FOOTHILLS WATER NETWORK

COMMENTS ON DRAFT ENVIRONMENTAL IMPACT STATEMENT (DEIS)

Yuba-Bear Hydroelectric Project (FERC #2266-102)
Licensee: Nevada Irrigation District

Drum-Spaulding Hydroelectric Project (FERC #2310-193)
Licensee: Pacific Gas & Electric Company

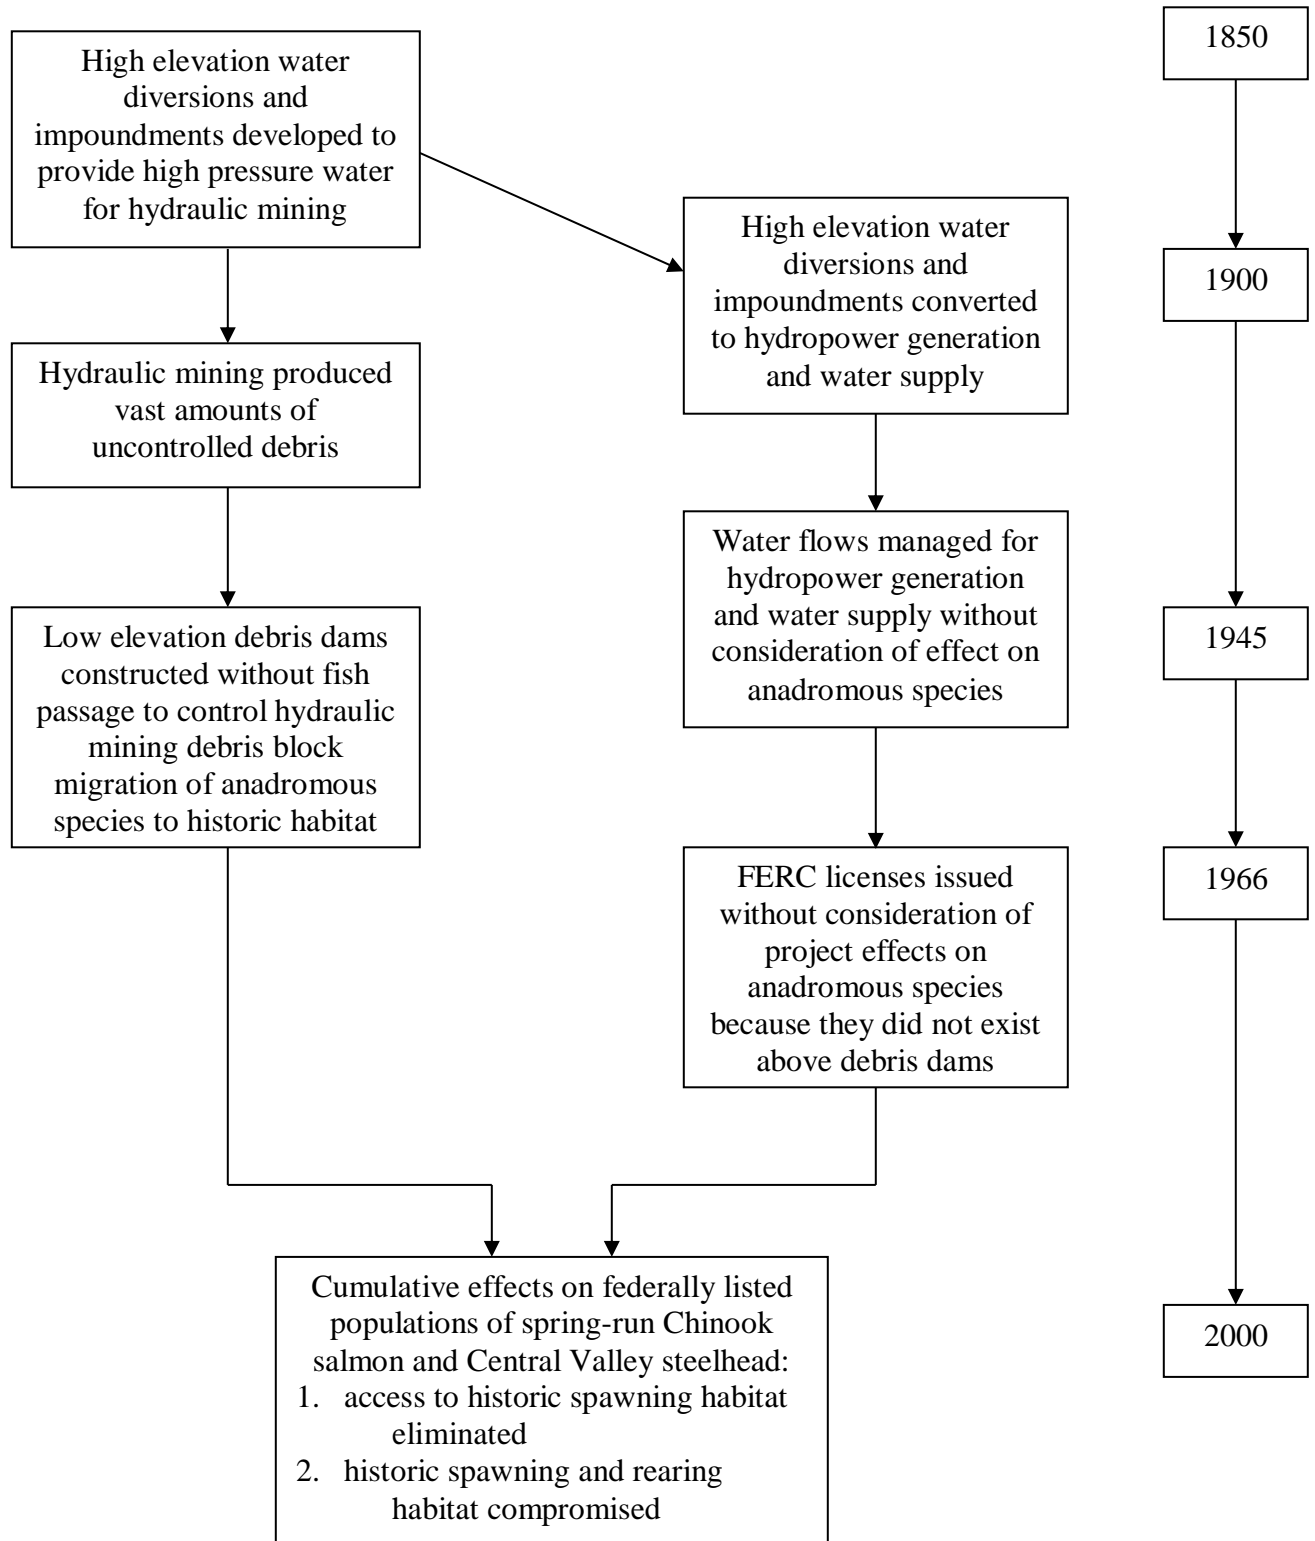
As stated, this analysis is perfunctory. The facts clearly point to past and on-going activities in the watershed that require further detailed cumulative effects analysis specific to the Yuba River watershed as a whole. The well-known history of mining, energy generation, debris management, water supply, and flood control projects in the Yuba River watershed began with the development of high elevation water diversions and impoundments to provide high pressure water for hydraulic mining (see Figure 1). Hydraulic mining produced vast amounts of uncontrolled debris that impacted anadromous fish habitat and had other far-reaching impacts downstream. Englebright Dam was a low elevation debris dam constructed for the purpose of controlling the hydraulic mining debris. Constructed without fish passage, Englebright Dam also blocked migration of anadromous species to their spawning grounds.

Taken together, the cumulative effects of past Project and other watershed activities, including mining, energy generation, debris management, water supply, and flood control within the Yuba River watershed as a whole and other project-affected streams resulted in and continue to result in or significantly contribute to:

In summary, FERC must provide a cumulative impacts analysis specific to the Yuba River watershed as a whole and other project affected streams that "...will identify other watershed activities including hydropower projects and will analyze the effects of the proposed project and alternatives in combination with other projects and activities" on Central Valley spring-run Chinook salmon and Central Valley steelhead. Results of the analysis may require development of mitigations that include the return of these species to their historic range and identifying actions necessary to mitigate cumulative effects on them.
